- Corrections HessD 10 C17-22, 2013

attached you will find the corrected version of our HESSD paper "Impact of long-term drainage on summer groundwater flow patterns in the Mer Bleue peatland, Ontario, Canada".

Reviewer 1

Figure 1 Comparison of cross section of our study site (A). with the Mer Bleue peatland margin shown in red and described in Fraser et al. (2001) (B).

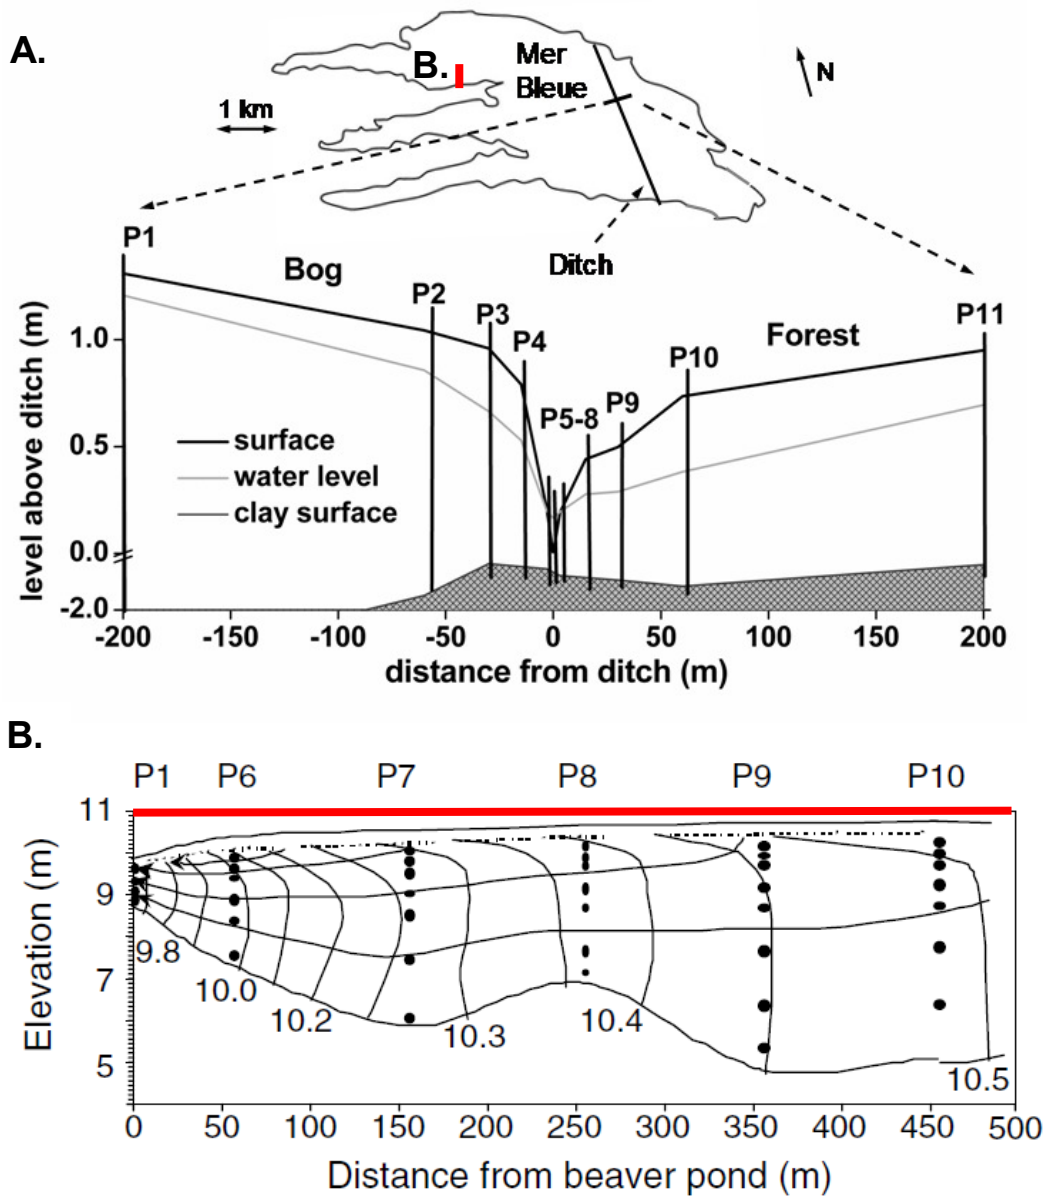
2. Provide evidence of uniform surface elevation and peat properties before drainage. Peat core dating may provide data needed to document whether or not drainage had effects beyond natural spatial heterogeneity.

Figure 1. The map and lines superimposed on the cross-section makes a somewhat cluttered image. I suggest separating these distinct informational images.

Regarding peat core dating see comments above. Surface elevation data from before 1923 are not available but there is strong comparative indication that the cross section that we in the paper describe in Figure 1 is not the original land surface.

An intact peatland margin of the Mer Bleue peatland has been described in terms of surface elevation previously (Fraser, C.J., Roulet, N.T., Lafleur, M.: Groundwater flow patterns in a large peatland. J. Hydrol. 246: 142–154. DOI: 10.1016/S0022-1694(01)00362-6, 2001). A cross section of from a lagg (P1) into the peatland margin located in a distance of 3 km west of our study site is shown below (Figure 1). The cross section illustrates the typical dome-shaped morphology of this bog on scales of half a kilometer. At the transect investigated in this study this characteristic surface slope is strongly altered with the ditch representing a local minimum in elevation instead.

The peat decomposition degree along the transect investigated here has previously been examined as well (Blodau, C., Siems, M., (2012): Drainage-induced forest growth alters belowground carbon biogeochemistry in the Mer Bleue bog, Canada, Biogeochemistry, 107(1-3), 107-123). This study documented that the peat near the ditch is much more decomposed than 200 m inland on the 'bog' side of the ditch. Furthermore it showed that on the 'forest' side the peat is more decomposed at the same distance from the ditch than on the 'bog' side. The remaining peat had also lost in decomposability, particularly at the forest side. Both findings suggest that peat was extensively mineralized near the ditch and particularly under the forest. These data are fully in line with a lowering of the land-surface, as documented in many other studies of peatland drainage before.

Here we cannot follow the reviewer's judgement. We asked a few colleagues and they found the image reasonably clear. We added another panel to the figure, however, to better illustrate the sampling design and the vegetation patterns in the area.
